**Amendments To The Drawings:**

**REMARKS/ARGUMENTS**

Application Serial No. 10/667,838  
Reply to Office Action of August 8, 2006

FIG. 5

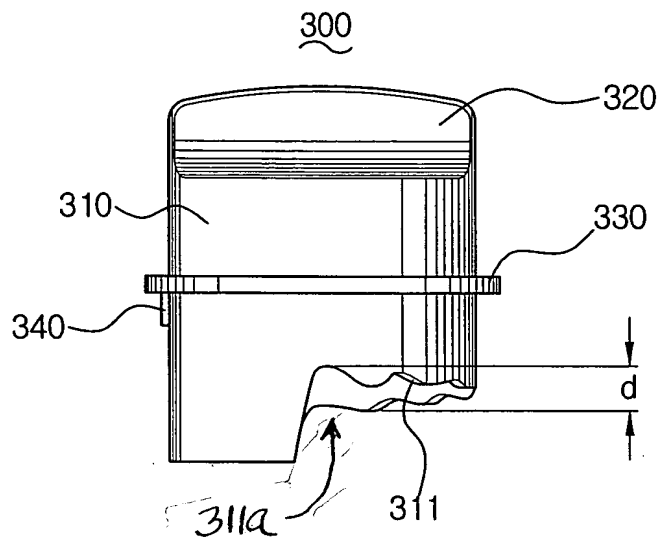
3. The drawings were also objected to because they did not include a reference numeral "311a" which is used in the specification to identify grooves in the height adjusting knob. In response, the Applicant has submitted herewith a replacement sheet for Fig. 5 and Fig. 6, and an annotated sheet showing the changes to Fig. 5 and Fig. 6. The Examiner will note that reference numeral "311a" has been added to both of these figures and this reference numeral identifies the grooves in the rotatable height adjusting knob.

The attached drawing sheets include changes to FIGS. 5 and 6. These sheets contain corrections highlighted in pink for the examiner's approval and are requested to replace the original sheet of FIGS. 5 and 6.
